HMC # 8962-90 Sh# 22

TITLE CONTRACT DWG. 1400-SIBAB92
ARR.1 CL.720 45°T.A.U. DISCH.
DIMENSIONS IN INCHES-NOT TO SCALE

2446D24

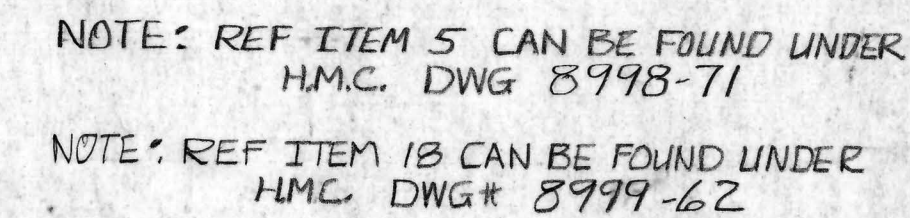
5.0 CF60/850B5	1	AC
D		
IT	CHANGE	
B/M WAS NOT COMPLETE SUPP.	2	AC
WERE NOT ON.		
DETAIL-B WAS CHANGED TO DETAIL-C.		
DETAIL-A WAS NOT ON.		
DIM. 3.00 WAS 3.50.		
ZONE E-7-STATIC		
WGT. WAS 16670.		
WGT. WAS 16670.		
WGT. WAS 16670.		
ROTOR GRWAS 257090.		
FXD. GRG. LOAD WAS 7310.		
22493. BRG. LOAD WAS 7310.		
NOTE-E WAS 56670 LB5		
FXD. BRG. WAS LOC-		
ZONE C-8 OUTBOARD END		
WGT. WAS 40000.		
K. CONNELL 01-02-86		
H009 WAS	3	AC
5911 C59H023		
H010 WAS		
5912 C59H022		
B/M WAS NOT		
COMPLETE		
VIEW B-B WAS NOT		
COMPLETE		
K/C 02-04-86		
18	4	
PART IDENT.		
24-6020H018		
NOTE-G WAS NOT		
COMPLETE.		
ZONE E-8 19-13.00		
WGT. WAS 16670.		
5.00 DIMS WERE NOT		
ON		
01 FEBRUARY 4/18/86		
<i>Shaw 442066</i>
